PRIMROSE SCHOOL

Re: Primrose School / Franklin County

This letter is written in follow-up to a construction storm water inspection that I conducted at the Primrose School located along Lamplighter Drive east of Buckeye Parkway in Grove City, Ohio on October 20, 2009. The purpose of the inspection was to evaluate compliance with the General Storm Water Permit Associated with Construction Activities. During the inspection, we noted the following:

Primrose School
Stabilize barren areas
Scioto River Watershed
October 20, 2009
Photo by: Greg Sanders

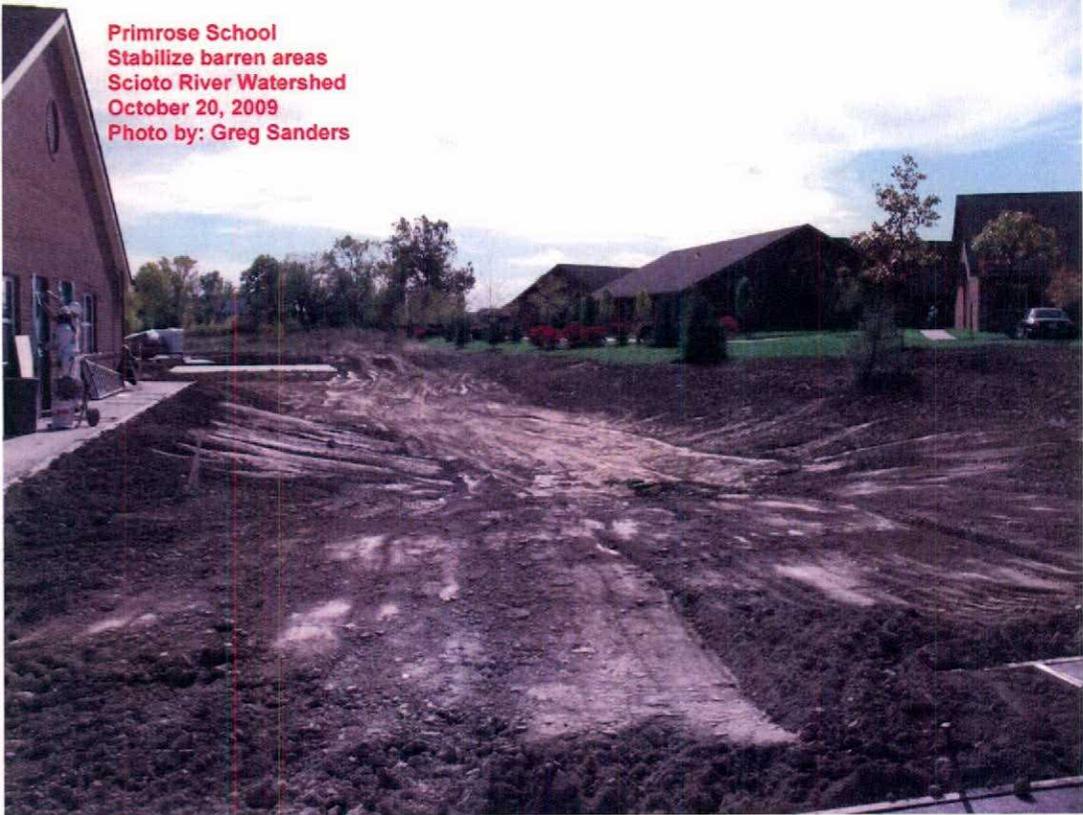
- The perimeter silt fence will require maintenance.
- Please be aware that the General Permit indicates that all sediment controls will be inspected and maintained every seven days or after a significant rain event. A log of inspection must be maintained on site for the agency to review.
- The dumpster that was stored at the end of Lamplighter Drive was leaking and needs to be repaired or replaced. Please see attached picture.
- Please be aware the General Permit states that all barren areas which remain idle in excess of 21 days must be protected from erosion within seven days of the last earth disturbing activities. In addition, erosion protection must be implemented for all areas of final grade within seven (7) days. Please see attached pictures.
